Shuttering Magnet Technical Parameter Update

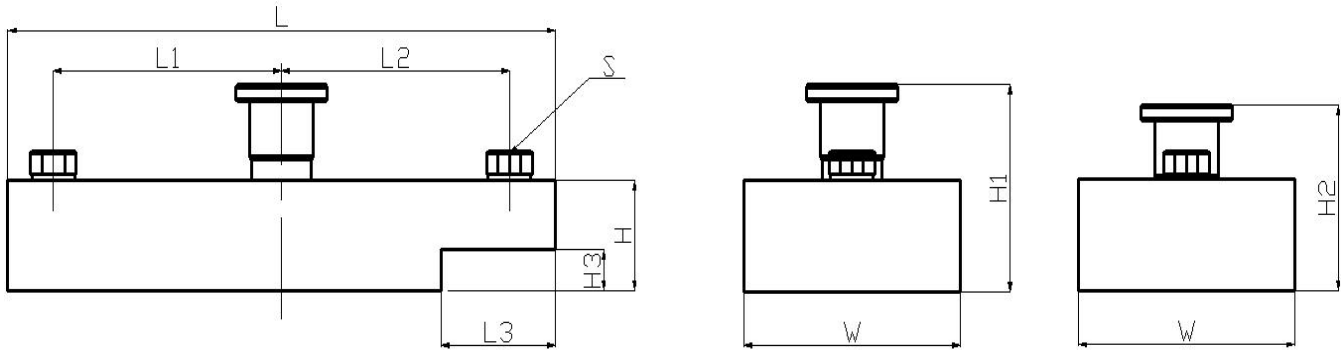
Item	L	W	H	L1	L2	L3	H1	H2	H3	S	
Kg	mm	mm	mm	mm	mm	mm	mm	mm	mm		
450	170	60	40	67.5	67.5	\	73	66.5	\	M12	
600	170	60	40	67.5	67.5	\	73	66.5	\	M12	
600-Step	200	60	40	72.5	97.5	42	73	66.5	10	M12	
800	190	95	43	67	93	50	80	73.5	10	M12	
900	280	60	40	122	122	\	73	66.5	\	M12	
900-Step	195	95	43	67	98	50	80	73.5	10	M12	
1000	200	95	43	67	100	50	80	73.5	10	M12	
1350A	320	90	60	135	135	\	98	90	\	M16	
1350-Step	320	90	60	113	161	47	98	90	\	M16	
1300	210	95	45	80	90	40	73	65	\	M16	
1600	270	120	60	110	110	\	98	90	\	M16	
1800	320	120	60	135	135	\	98	90	\	M16	
2100	320	120	60	135	135	\	98	90	\	M16	
2400	320	120	60	135	135	\	98	90	\	M16	
2600	320	120	60	135	135	\	98	90	\	M16
